PIC16(L)F1933 Silicon Errata and Data Sheet Clarification

The PIC16(L)F1933 family devices that you have received conform functionally to the current Device Data Sheet (DS41575C), except for the anomalies described in this document.

The following typographic corrections and clarifications are to be noted for the latest version of the device data sheet (DS41575C).

FIGURE 1: INSTRUCTION CYCLE DELAY CALCULATION EXAMPLE

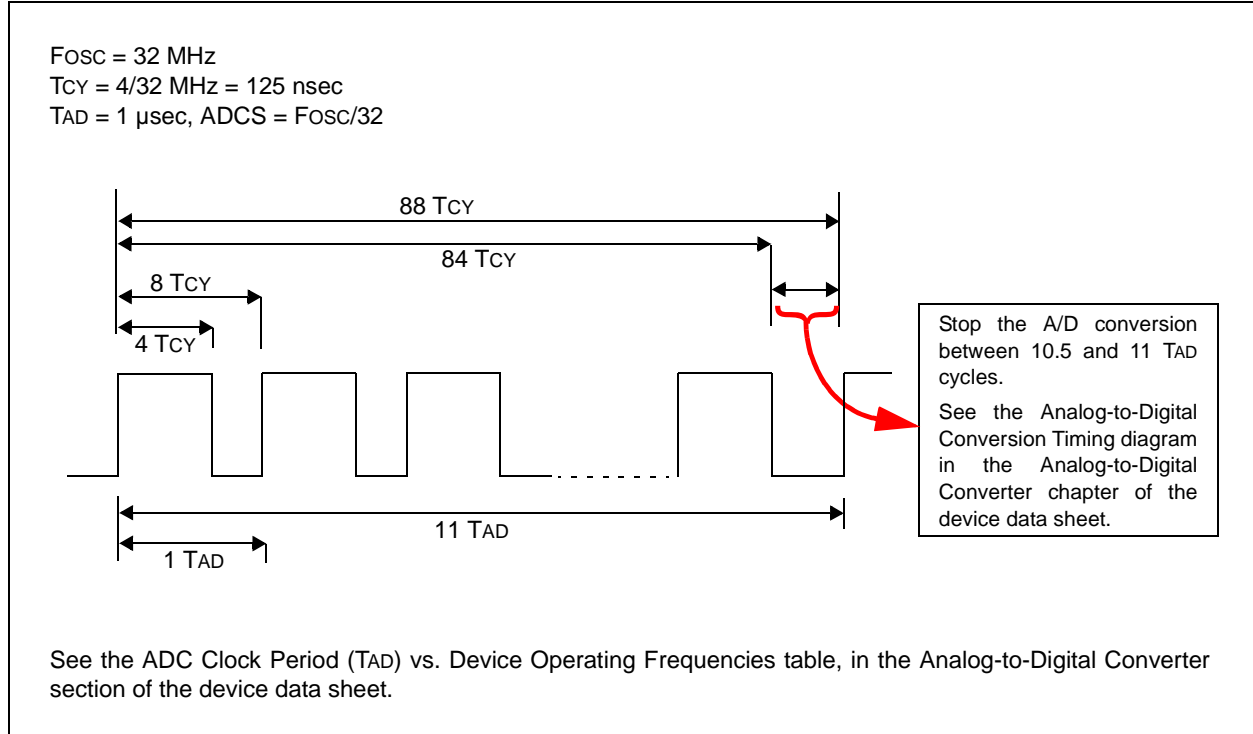
An ADC conversion may not complete under these conditions:

1. When FOSC is greater than 8 MHz and it is the clock source used for the ADC converter.
2. The ADC is operating from its dedicated internal FRC oscillator and the device is not in Sleep mode (any FOSC frequency).

When this occurs, the ADC Interrupt Flag (ADIF) does not get set, the GO/DONE bit does not get cleared, and the conversion result does not get loaded into the ADRESH and ADRESL result registers.

Method 3: This method is provided if the application cannot use Sleep mode and requires continuous operation at frequencies above 8 MHz. This method requires early termination of an ADC conversion. Provide a fixed time delay in software to stop the A-to-D conversion manually, after all 10 bits are converted, but before the conversion would complete automatically. The conversion is stopped by clearing the GO/DONE bit in software. The GO/DONE bit must be cleared during the last ½ TAD cycle, before the conversion would have completed automatically. Refer to [Figure 1](#) for details.

In [Figure 1](#), 88 instruction cycles (Tcy) will be required to complete the full conversion. Each TAD cycle consists of 8 Tcy periods. A fixed delay is provided to stop the A/D conversion after 86 instruction cycles and terminate the conversion at the correct time as shown in the figure above.

Note: The exact delay time will depend on the TAD divisor (ADCS) selection. The Tcy counts shown in the timing diagram above apply to this example only. Refer to [Table 4](#) for the required delay counts for other configurations.

FIGURE 5-4: CERAMIC RESONATOR OPERATION (XT OR HS MODE)

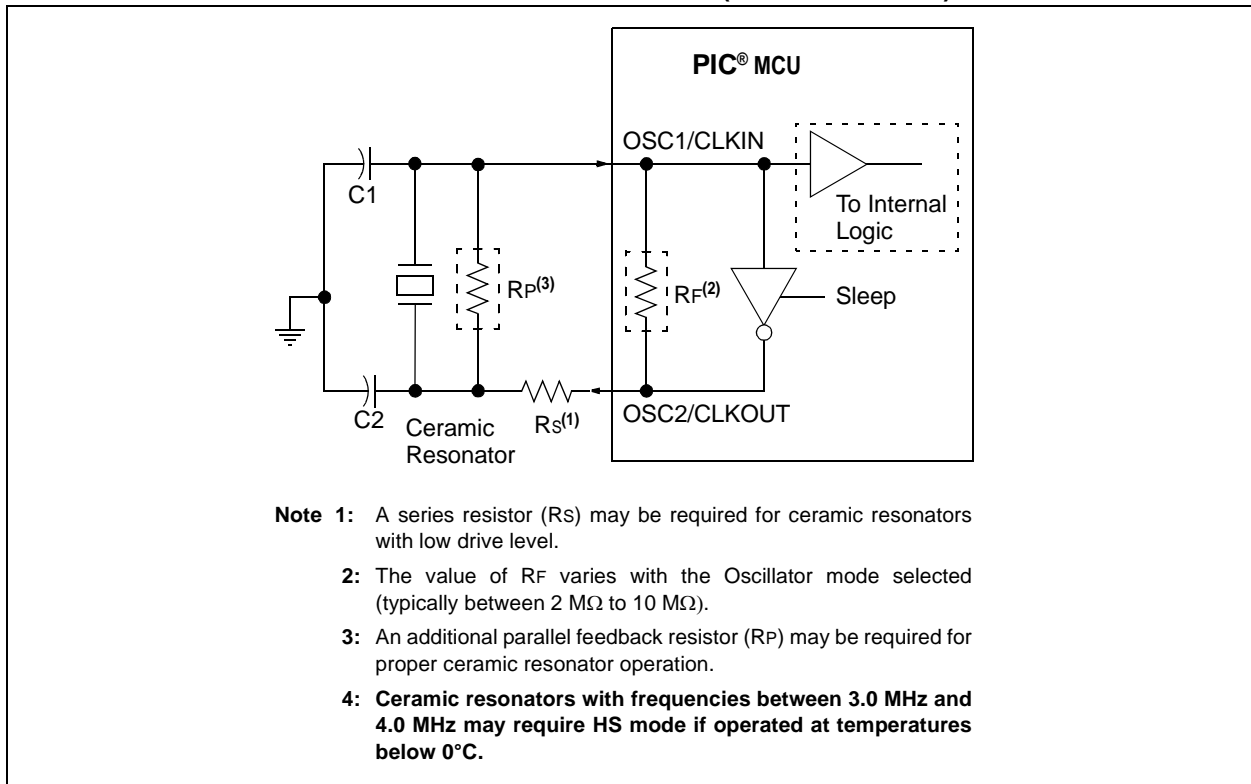
In [Figure 5-4](#), note 4 is added as following:
